SUNDRY NOTICES AND REPORTS ON WELLS (DO NOT USE THIS FORM FOR PROPOSALS TO DRILL OR TO DEEPEN OR PLUG BACK TO A DIFFERENT RESERVOIR. USE "APPLICATION FOR PERMIT" (FORM C-101) FOR SUCH PROPOSALS.)		WELL API NO. 30-015-34794

PERFORM REMEDIAL WORK ☐ PLUG AND ABANDON ☐
TEMPORARILY ABANDON ☐ CHANGE PLANS ☒
PULL OR ALTER CASING ☐ MULTIPLE COMPL ☐
OTHER: Revise BHL, MD, Well Name ☒

RE: Bold Energy, L.P.
C-103 Revise BHL, MD, Well Name
Delilah State # 1H
Wildcat; Wolfcamp Gas Field
Sec 36, T18S, R21E
Eddy County, New Mexico
API # 30-015-34794

Enclosed is the last amended C103 on the above referenced well, dated 7/17/06. This request seeks approval to revise the Bottom Hole location, the Well Name, and the Measured Depth of said well.

WELL LOCATION AND ACREAGE DEDICATION PLAT

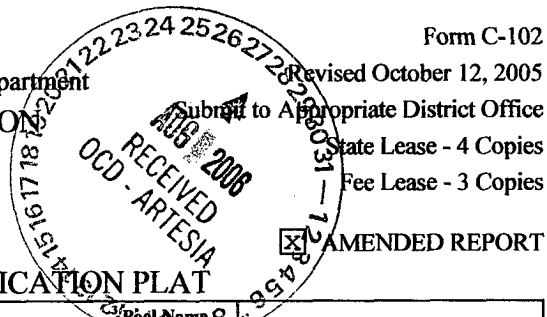
Change Bottom Hole Location from Unit D, 660' FNL, 660' FWL to new Bottom Hole Location:

Unit Letter "C" 660' FNL & 1980' FWL of Sec 36 - T18S - R21E

Change Lease Name from "Delilah State" to: Delilah State Com

UL or lot no.	Section	Township	Range	Lot Idn	Feet from the	North/South line	Feet from the	East/West line	County
C	36	18S	21E		660	North	1980	West	Eddy

Plan 2: Q5497.gps32

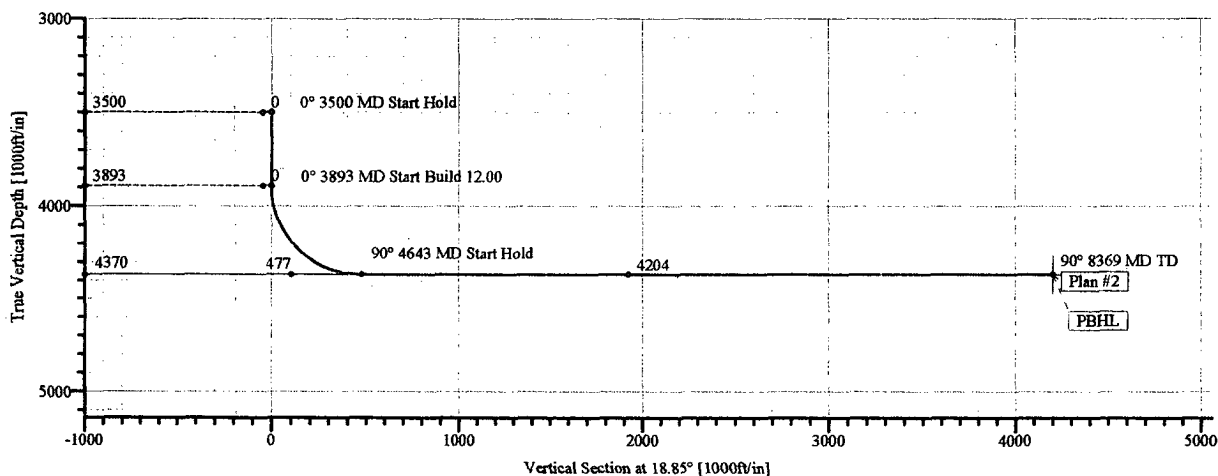
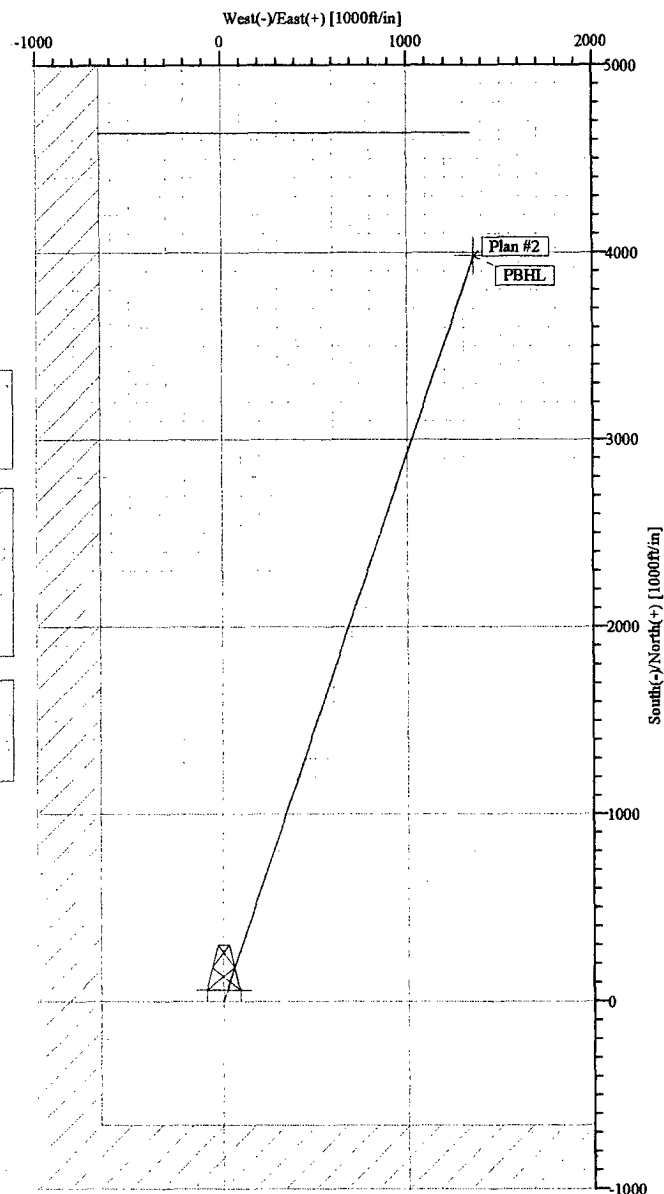
With the change in directional plan, the estimated Total MD is now: 8369'

SECTION DETAILS										
Sec	MD	Inc	Azi	TVD	+N/-S	+E/-W	DLeg	TPacc	VSec	Target
1	3500.00	0.00	18.85	3500.00	0.00	0.00	0.00	0.00	0.00	
2	3892.54	0.00	18.85	3892.54	0.00	0.00	0.00	0.00	0.00	
3	4642.54	90.00	18.85	4370.00	451.86	154.24	12.00	18.85	477.46	PBHL
4	8369.40	90.00	18.85	4370.00	3978.90	1358.20	0.00	0.00	4204.33
